Fire Risk Assessment

1-26, 50 Well Street

Version 5

5 October 2023

Example of fire stopping within riser cupboards

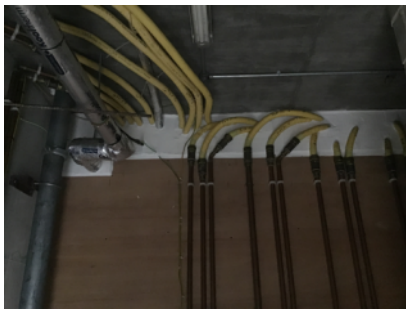
Some fire stopping has been installed in riser cupboards, however, this has been installed in some penetrations and not others. Also, where fire stopping has been installed, often it was found to be of an unacceptable standard.

Fire stopping within gas meter room

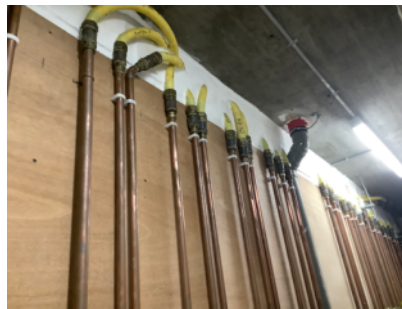
It appears fire stopping has been installed through the vertical levels of the gas riser. This may compromise the required ventilation for this riser. It is advised advice is sought from the appropriate gas supply body to ensure that this complies and does not contradict with ventilation requirements.
